DATE: January 8, 2020

<u>Certificate of Appropriateness Request:</u>	H-02-20
<u>Applicant:</u>	Andrew Westin – Buzz City Games
<u>Location of subject property:</u>	4 Union Street, North
<u>Staff Report prepared by:</u>	Kristen Boyd-Sullivan, Sr. Planner

Exhibit C

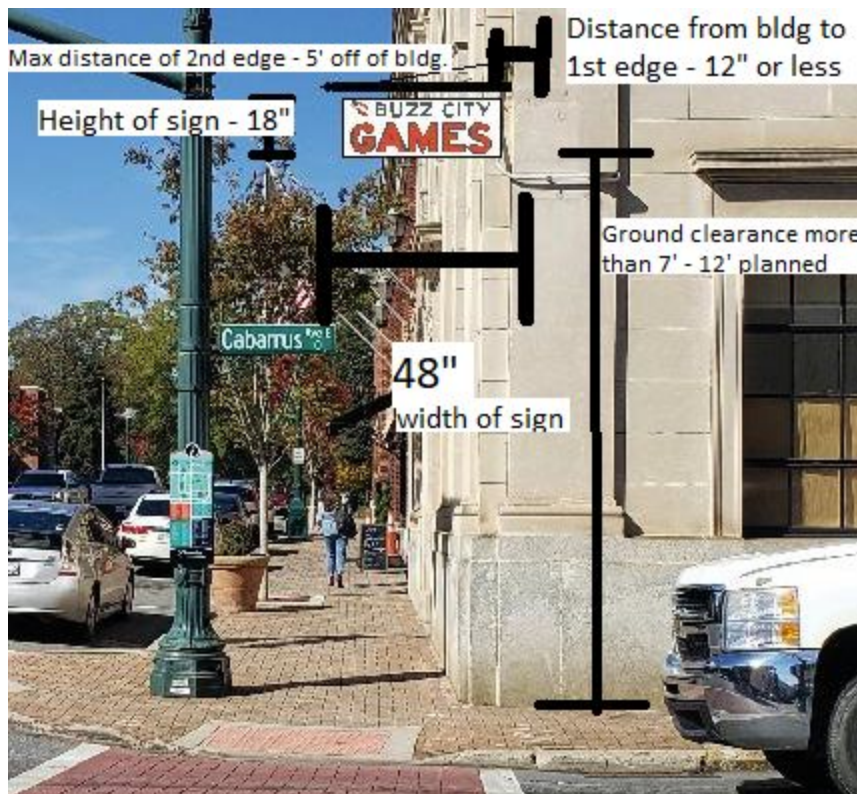
The applicant is seeking approval for the installation of two (2) projecting wall signs. As shown on the attached renderings (Exhibit C), both signs are identical in design, materials, and size. As indicated in Exhibit C, each sign itself is made from PVC and each sign face is 48”X18” (6sf). The signs would be classified under the Concord Development Ordinance as “projecting signs” they are adhered perpendicular to the face of the building by a bracket arm. The propose bracket arm is indicated as black powder coated aluminum.

The Concord Development Ordinance Article 12 “Signs,” details specific requirements for projecting signs including maximum size (6sf), maximum wall projection distance (5ft), and location. The proposal is in conformance with all requirements related to the Concord Development Ordinance sign standards.

Although the Historic Handbook does not specify standards for signage within the Historic District or for Local Landmarks, approval of signage by the HPC is required. The Commission should consider location, architectural design, and whether the addition of signage would compromise the Historic integrity of the structure when making a determination of appropriateness. Incorporated into the Historic Handbook, the Secretary of the Interior’s Standards, echo preventing the limitation damage. Finally, a relatively recent Supreme Court ruling prohibits municipalities from regulating sign content. Therefore, the Commission should not consider the content (images and wording) within the signage during deliberation.
